Subject: Final Report for Potential 10 CFR 21 Notification SOR Test Report 9058-102 Revision 2

SOR is providing this report in accordance with 10CFR Part 21.21. This letter serves as a final report to our interim notification letter dated December 15, 2017.

SOR Qualification Test Report 9058-102 Revision 2

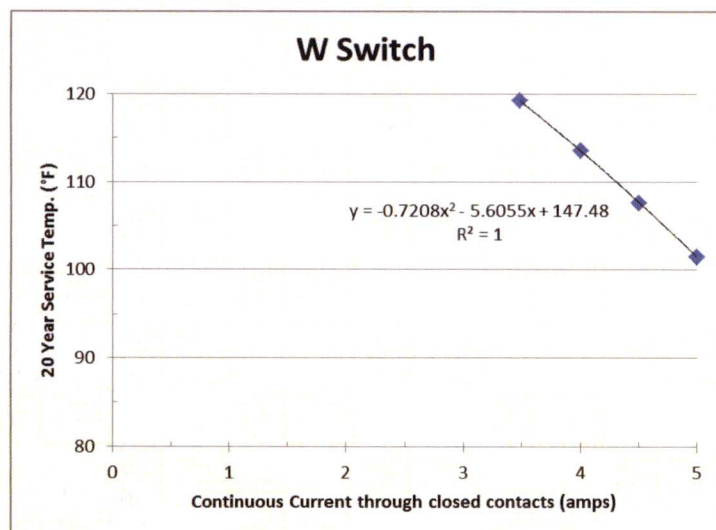
EFFECT OF ELECTRICAL LOAD ON QUALIFIED LIFE

This issue is addressed in SOR Test Report 9058-102, Section 9. If this was not previously been taken into account by the end user, it should be evaluated for every application. SOR will be adding the following supplemental information to Revision 3 of Test Report 9058-102 as an aid to help determine effects of electrical load on qualified life.

The SOR pressure, vacuum, and temperature switches are mechanical "On-Off" devices that do not require power to operate. Heat rise will only occur within the devices if the switch element contacts are closed and if there is enough current running through the closed contacts to create a rise in temperature in the current carrying wires and switch terminals. If there is enough temperature rise, this could reduce the qualified life of the switch. The following assumes worst case where the ambient temperature is at 119.257°F continuously, the contacts are closed at all times, and there is current running through the closed contacts continuously throughout the life of the switch.

For switches with a "W" switch element (3rd position in the model string) and "NQ" or "NQX" at the end of the model string, the effect on qualified life would be as noted below. Non-standard models 9013545 and 9013761 are also affected. This is based on an activation energy of 1.32 eV.

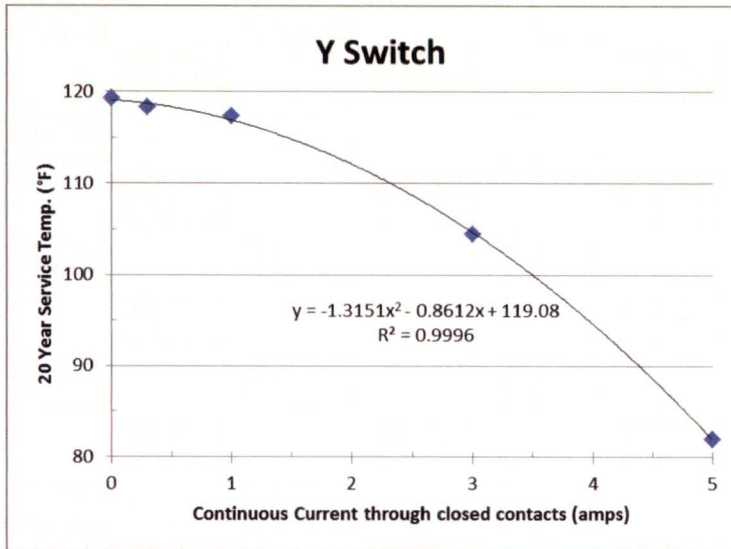
For switches with a "Y" switch element (3rd position in the model string) and "NQ" or "NQX" at the end of the model string, the effect on qualified life would be as noted below. This is based on an activation energy of 1.05 eV.

"W" or "Y" Switch Element

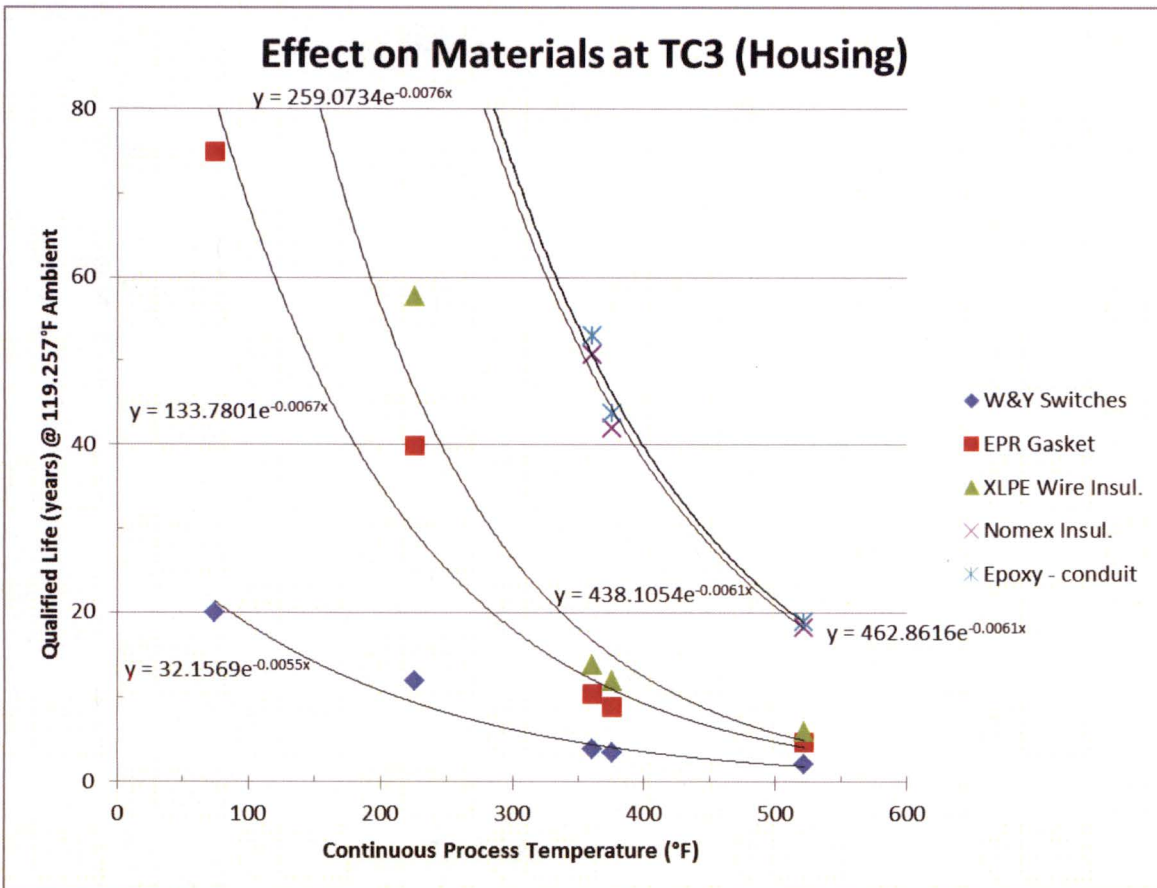
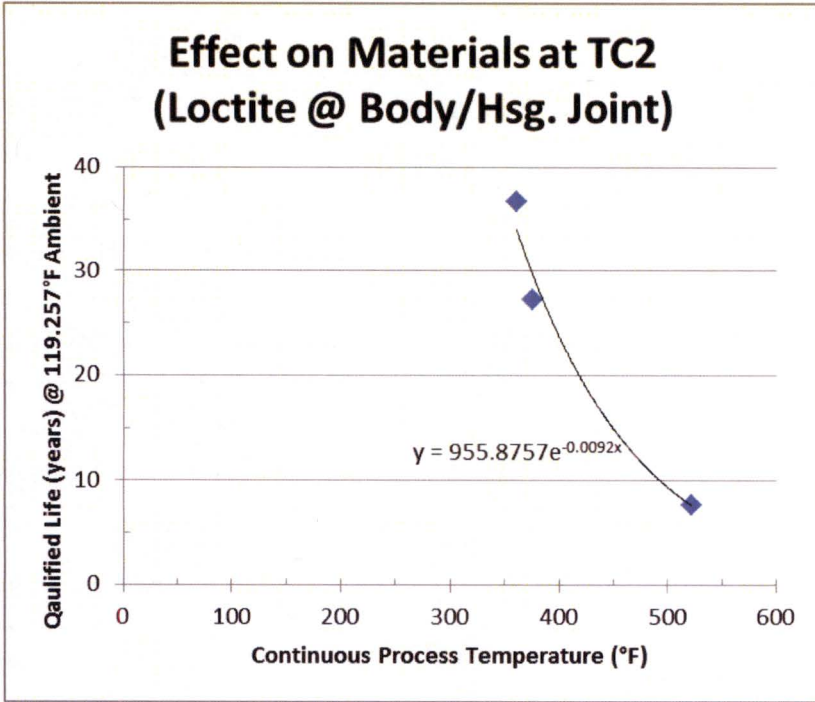
Assume that the switch contains a "W" or "Y" switch element (3rd position in the model string). Then the qualified life could be calculated by the formula $y=32.1569 e^{(-0.0055x)}$ where "y" is the qualified life in years (assuming 119.257°F ambient), and "x" is the process temperature in degrees Fahrenheit (assuming continuous exposure to this temperature). This formula represents the weak link up to a process temperature of 225.3°F at which point the weak link becomes the EPR O-ring environmental seal between the sensor and the body. Then the qualified life could be calculated by the formula $y=170.3670 e^{(-0.0129x)}$. This formula represents the weak link up to a process temperature of 520°F which is the highest rated over-range temperature available in an SOR nuclear qualified temperature switch.
